91-28

## A. REQUIRED WATER SEPARATING FUEL FILTER REPLACEMENT

### Models Affected

**Figure 1.**

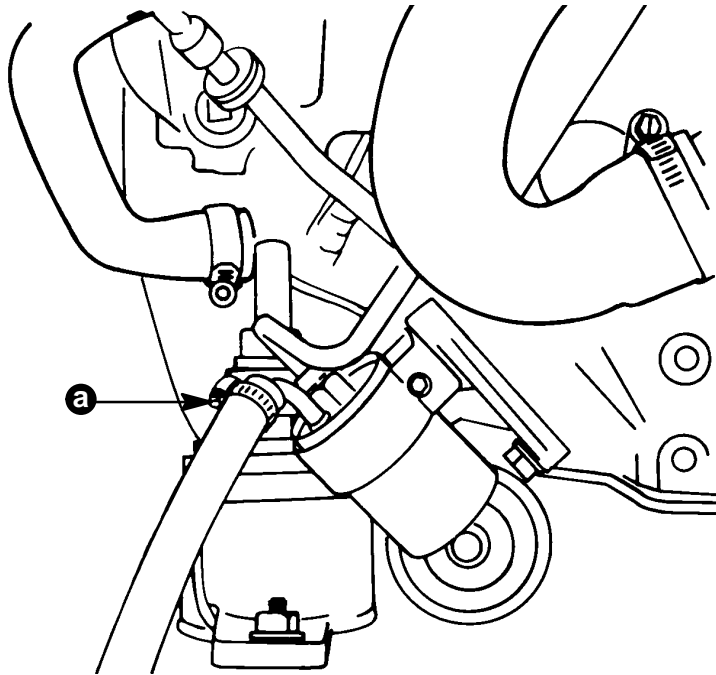
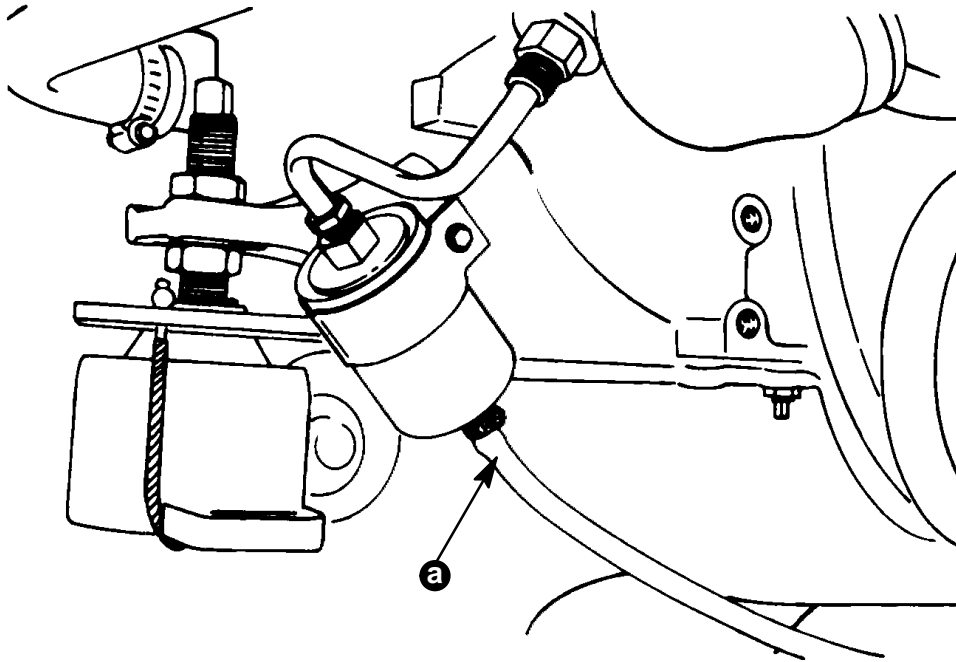
The first type of fuel filter installed on these engines may have the wrong type of metal or weld in it. Refer to Figure 1 for identification. The boat's fuel line is connected on the top of the filter.

Order a new filter. New filter will have the boat's fuel line connected to the bottom of the filter as shown in Figure 2.

(1) 35-805031T Fuel Filter
